E/ECE/324 } Rev.2/Add.99/Amend.1  
E/ECE/TRANS/505 }

#### **Addendum 99: Regulation No. 100**

#### **Amendment 1**

### **UNIFORM PROVISIONS CONCERNING THE APPROVAL OF BATTERY ELECTRIC VEHICLES WITH REGARD TO SPECIFIC REQUIREMENTS FOR THE CONSTRUCTION AND FUNCTIONAL SAFETY**

Figure 7.1  
**Determination of hydrogen emissions during  
 the charge procedures of the traction battery**

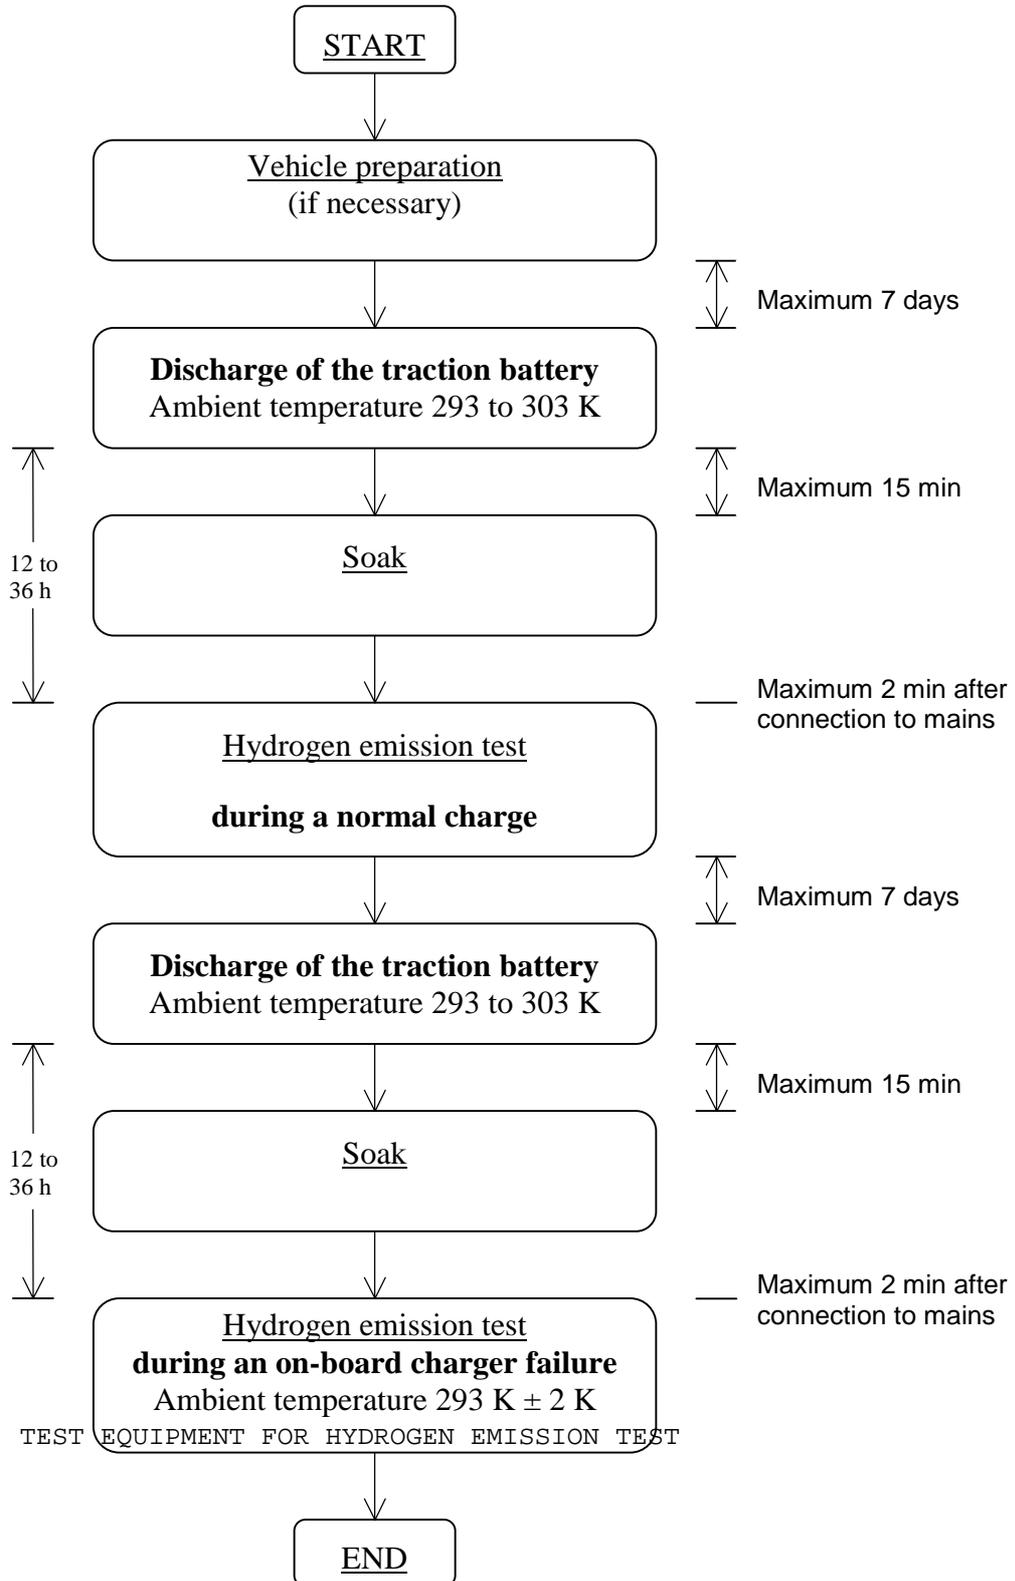
Insert a new Annex 7, with Appendices 1 and 2, to read:

The hydrogen emission test (Figure 7.1) is conducted in order to determine hydrogen emissions during the charge procedures of the traction battery with the on-board charger. The test consists in the following steps:

- (a) vehicle preparation,
- (b) discharge of the traction battery,
- (c) determination of hydrogen emissions during a normal charge,
- (d) determination of hydrogen emissions during a charge carried out with the on-board charger failure.
